T1	TENDER ADDENDUM	TK	CS	09.02.2018
T	TENDER	TK	CS	31.01.2018
P	PRELIMINARY	TK	CS	12.01.2018
REV	PURPOSE OF ISSUE	BY	APP	DATE

PROJECT
Herbal House

DRG. TITLE
LEVEL 5 LIGHTING LAYOUT

DRG. NO.	SCALE	REV.
E35017-LT-5-100	1:100@A2	T1

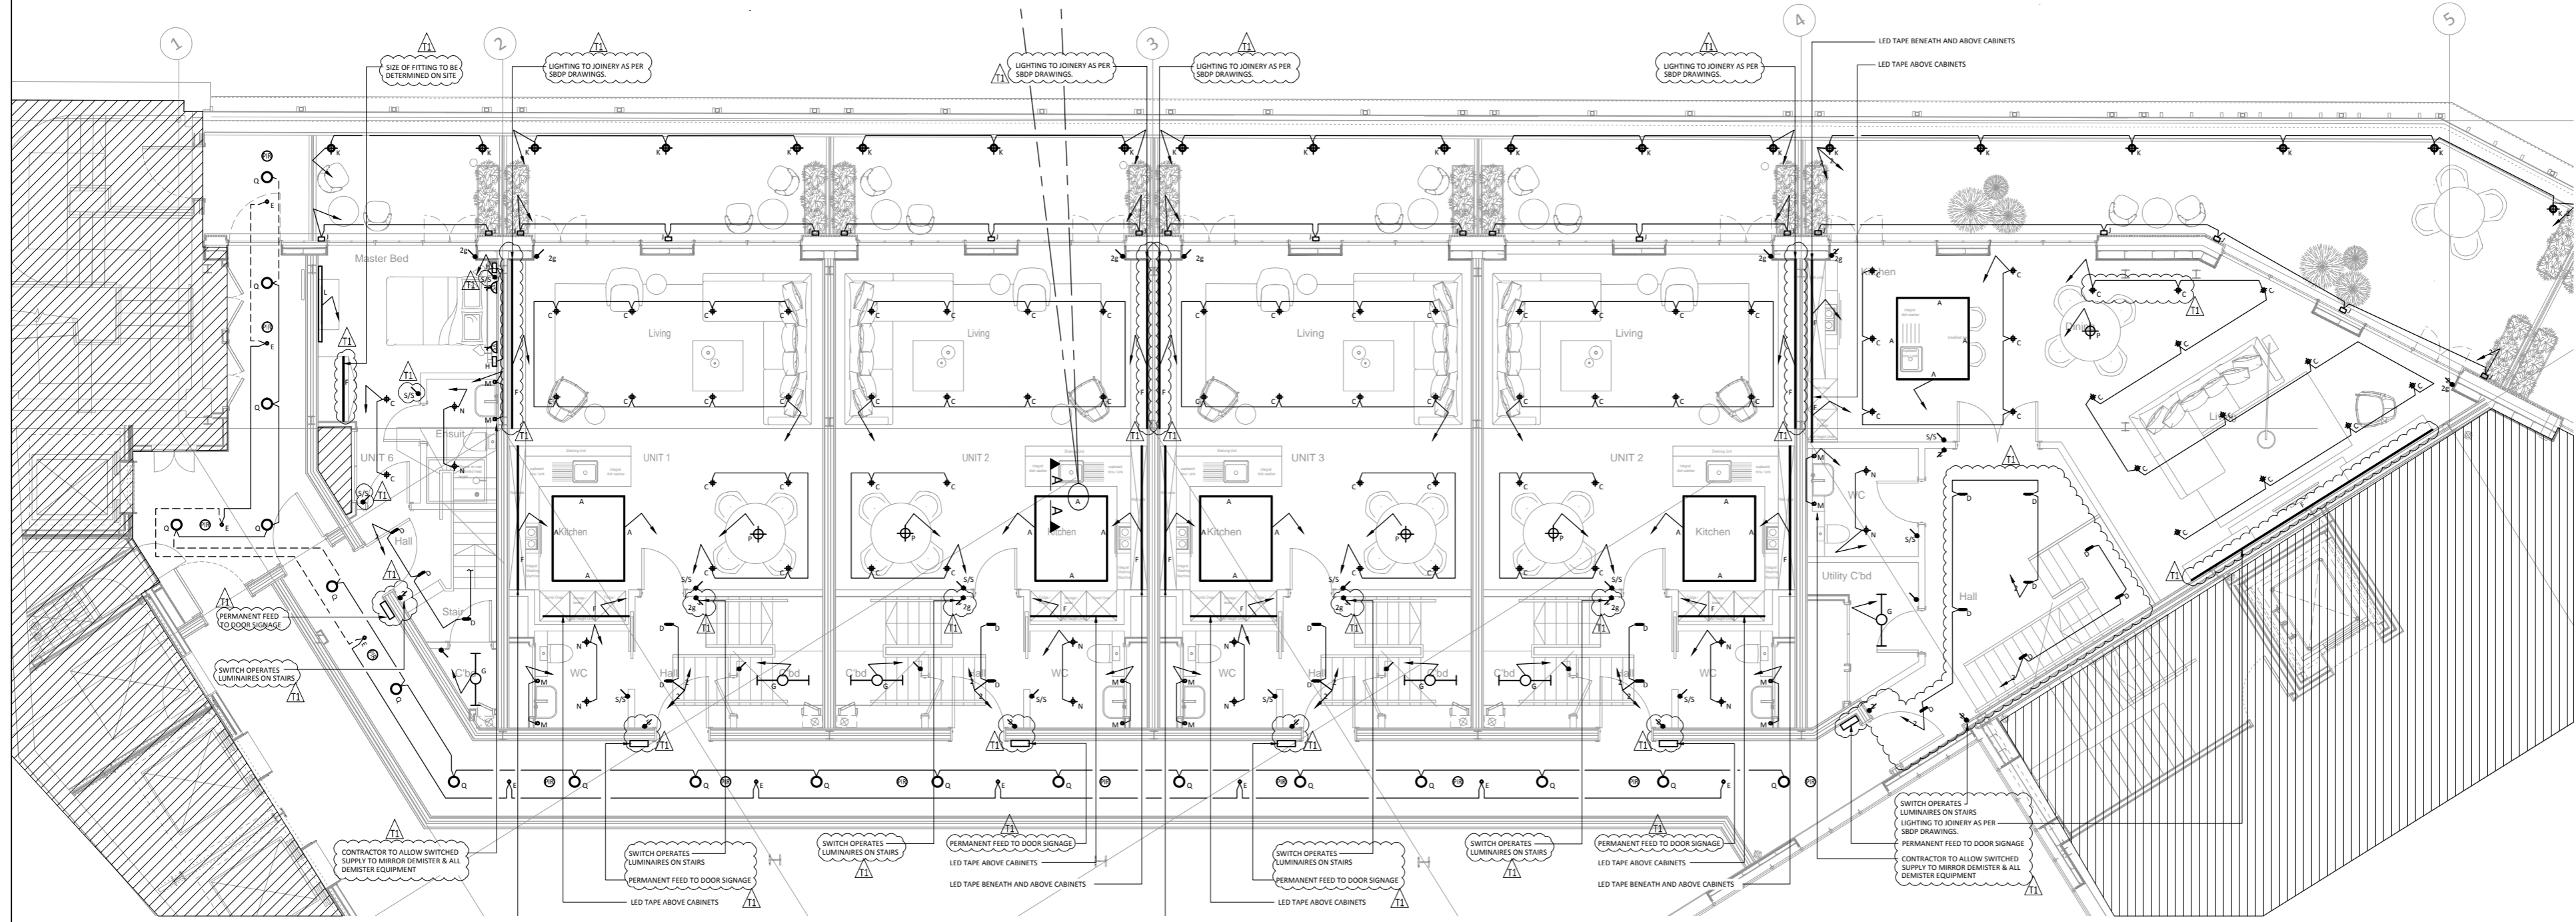
CONTRACTOR TO MAKE ALLOWANCE TO PROVIDE LIGHTING TO NICHE SHELVES WITHIN BATHROOM & EN-SUITES IN ACCORDANCE WITH SBDP INTERIOR DESIGN DRAWINGS.
